# Technical Service Information

## NISSAN 4N71B HARSH 4-3 COAST DOWNSHIFT

Figure 1

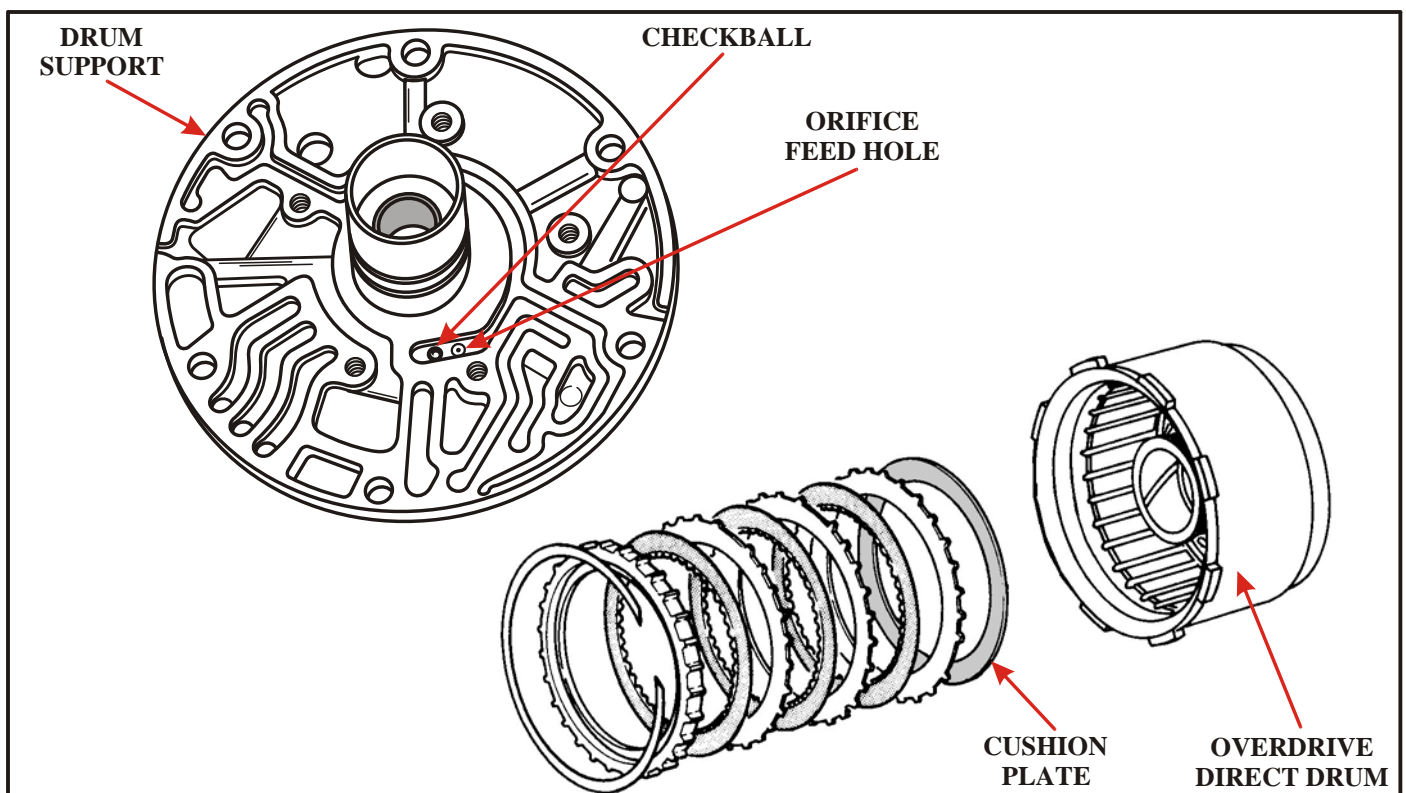
**COMPLAINT:** Some vehicles may exhibit a harsh coast downshift bump going from fourth to third.

**CAUSE:** The cause may be, a mis-matched overdrive direct clutch drum assembly and the overdrive drum support. The cushion plate arrangement in the overdrive direct drum and the size of the overdrive direct clutch feed hole located in the drum support. Some drum supports also require a checkball depending on cushion plate arrangement. Refer to Figure 1.

Figure 2

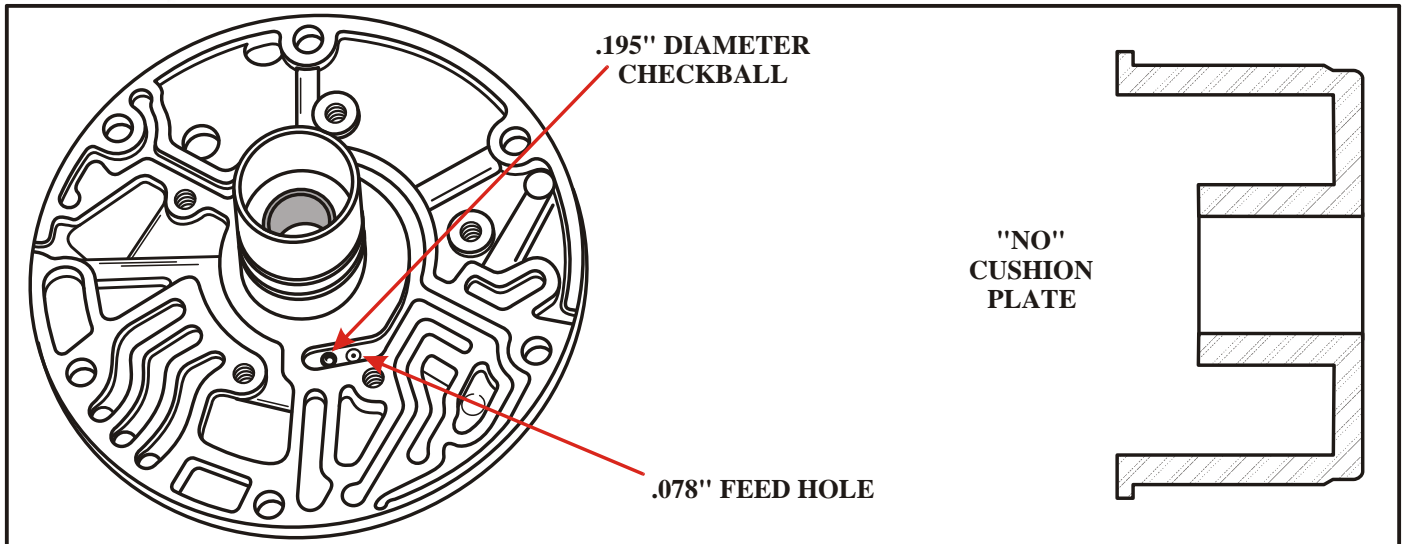
**CORRECTION:** There are three different combinations that match and provide acceptable results, and are as follows:

- (1) The drum support has a .078" orifice feed hole and requires a .195" checkball. The overdrive direct drum clutch stack **does not** use a cushion plate (See Figure 2)
- (2) The drum support has a .115" orifice feed hole and also requires a .195" checkball. The overdrive direct drum clutch stack requires **one** cushion plate (See Figure 3).
- (3) The drum support has a .115" orifice feed hole, but the checkball has been removed due to the overdrive direct drum clutch stack requiring **two** cushion plates installed in the direction illustrated in Figure 4.
